Submission by Mallard Pass Action Group (MPAG)

Deadline 9:

**Comments on the Applicant's
Responses (REP8-019) at D8
to D7 submissions
of Interested Parties**

Insert 40: Extract from the ALC

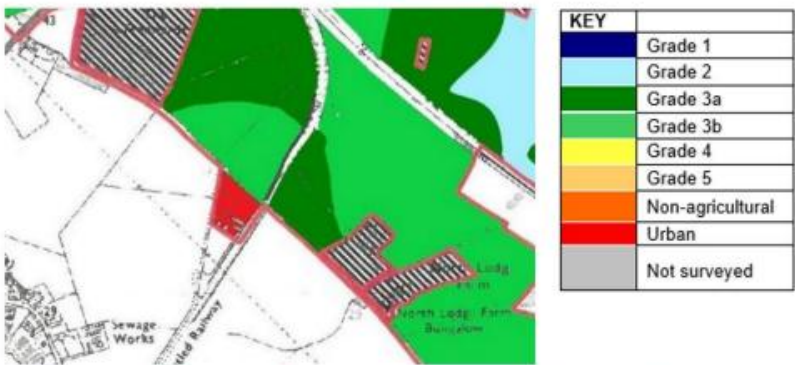
One of the key aspects of site selection is ascertaining the ALC grade of land to be permanently lost as a result of the Proposed Development being consented. However, this was not the case for the substation as only a semi-detailed survey of the area was ever conducted as clearly outlined in the Auger Points Plan in Appendix 12.4 Land Use & Soils- ALC survey (APP-091) and highlighted by MPAG in their Landscape report (REP7-060). It is now clear from the latest changes made to the oSMP vs6 (REP8a-005), that a retrospective requirement has been put in place to conduct a detailed ALC grading of that area.

Additionally the oSMP has acknowledged that the original downgrading of the area to 3b was not a reliable assessment and until the detailed survey is conducted for the substation area, no ALC grade can be claimed at this stage. The stage 1 auger sampling showed a large area of 3a right in the location that the substation is planned for in field 19.

~~40-7~~10.8 The area for the substation will be subject to detailed survey pre-construction. The area for the substation is therefore all Subgrade 3b.
